SUBJECT: Bulletin "B" Dated December 10, 2020

PROJECT #: P1173-00 Re-Bid

DESCRIPTION: Campsite Electric and Water Service
CCC Camp, Belleplain State Forest
Woodbine, Cape May County, NJ

BULLETIN B

ROADWAY PAVEMENT SECTION
 (LOOKING SOUTH)
 NOT TO SCALE

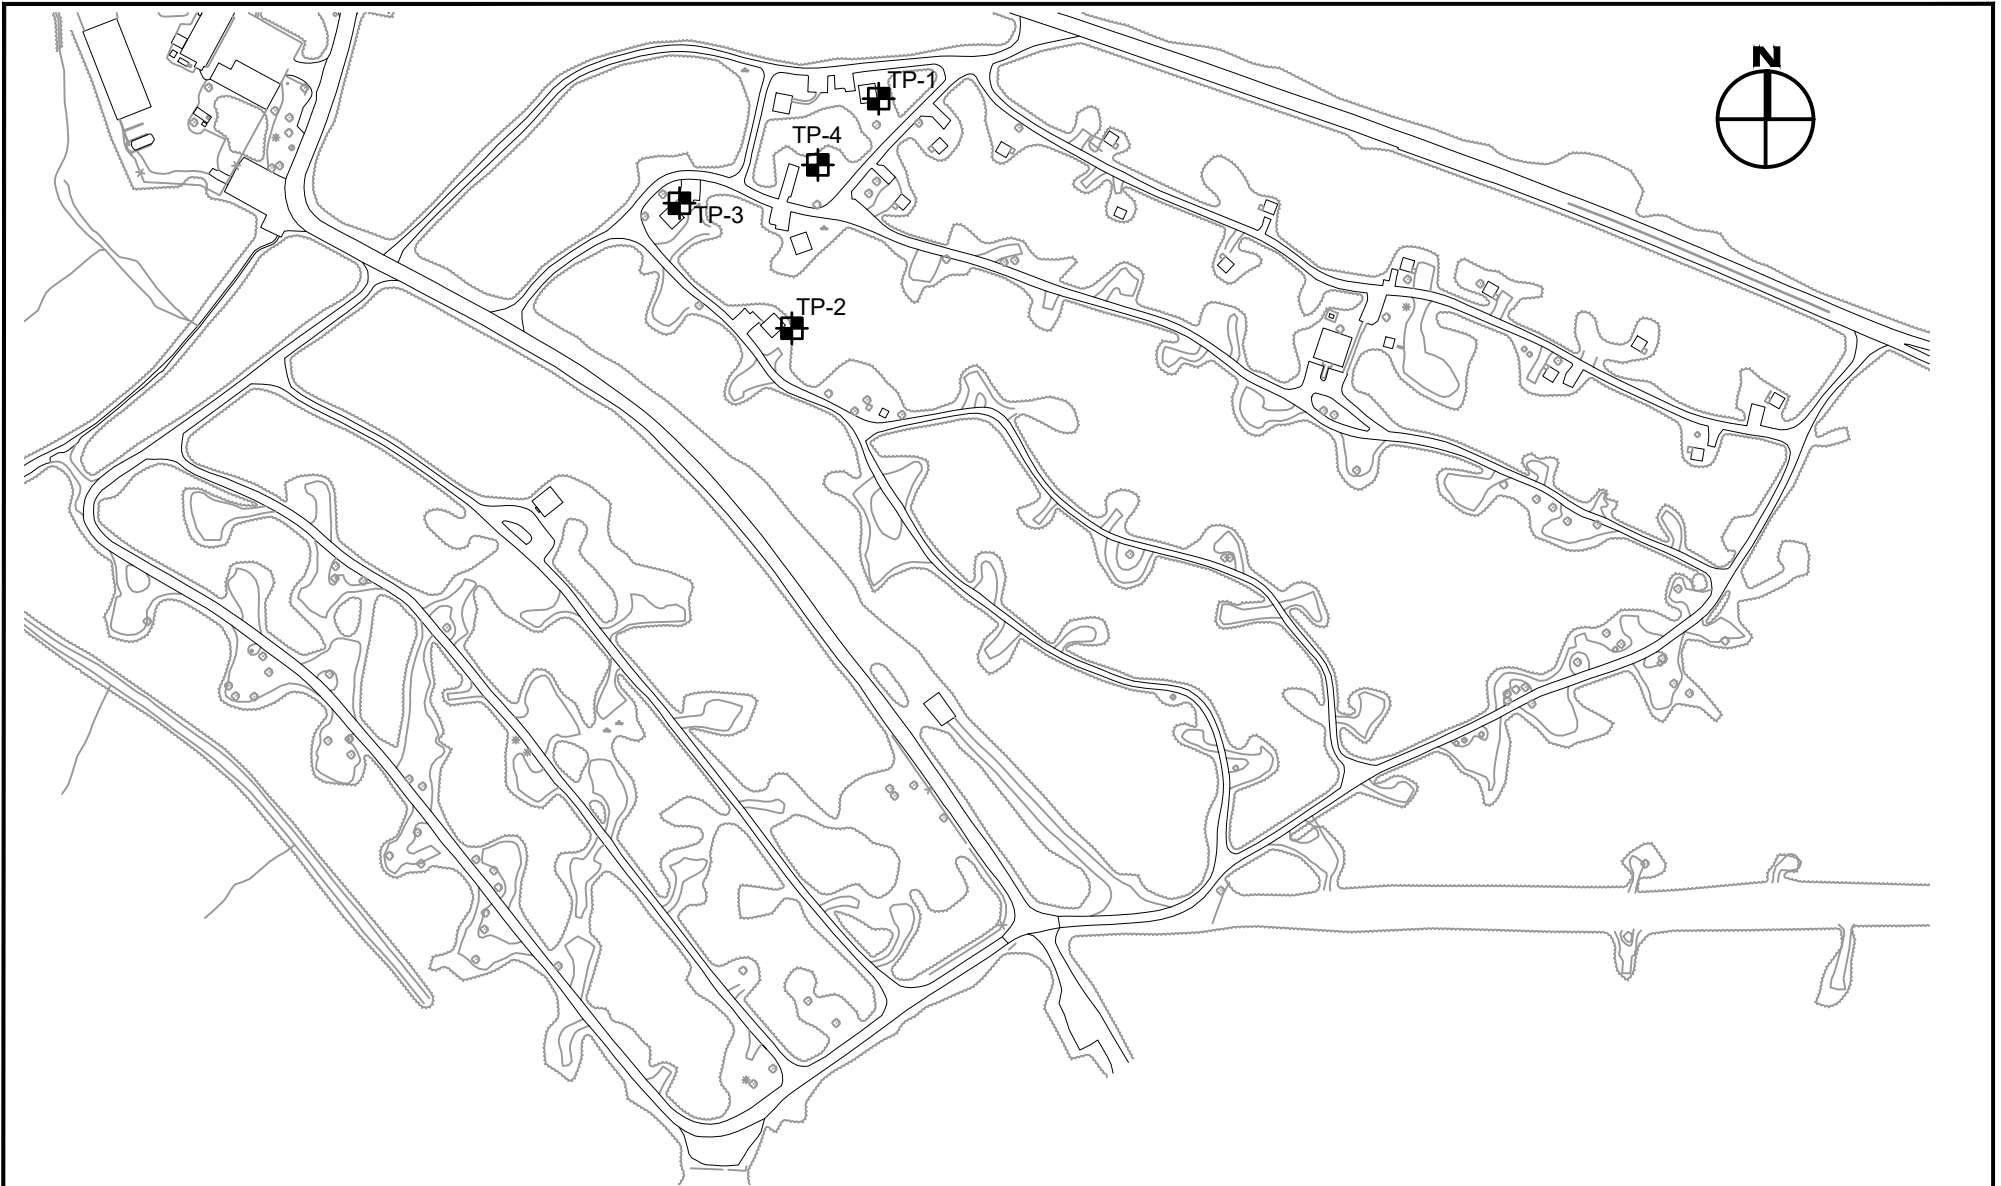
Q32. Please provide the thickness of existing asphalt road in the CCC camp area and Meisle field camp area for saw cutting the existing roads.

R32. Refer to Bulletin B, Attachment No. 3 – Sketch SK-1, As-Built Roadway Pavement Section.
